Recall Bulletin

File In Section: Product Recalls
Bulletin No.: 04006
Date: April 2004

SUBJECT: ELECTRONIC COLUMN LOCK SYSTEM

MODELS: 1997 CHEVROLET CORVETTE EQUIPPED WITH AN AUTOMATIC TRANSMISSION (EXCLUDES EXPORT VEHICLES)

1489425

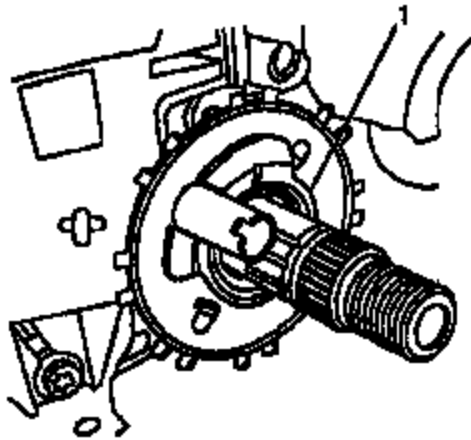
30. Using J 23653-SIR or J 23653-D (2), remove the retaining ring and the lock plate (1) and discard both.

1489489

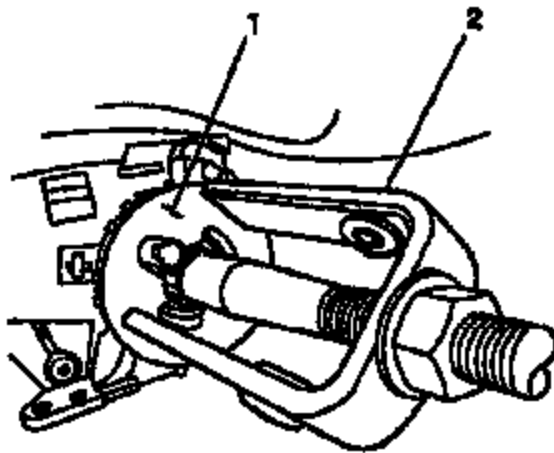
31. Align and position the cam orientation plate (1), included in the kit, on the steering column shaft.

1489426

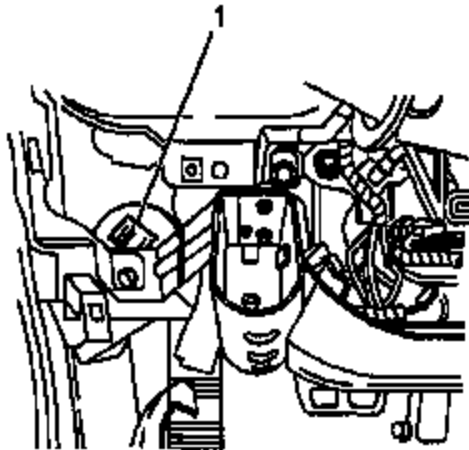
32. Using J 23653-SIR or J 23653-D (2) and J 42137 (1), install the cam orientation plate and the new retaining ring included in the recall kit. The cam orientation plate replaces the lock plate removed in the previous step.
33. Position the SIR coil on the steering column and install the snap ring.
34. Disconnect the electrical connector from the ECL, located on the right lower side of the steering column.

When installing the cam orientation plate in the next step, a **NEW** retaining ring must be used. Do not reuse the original retaining ring.
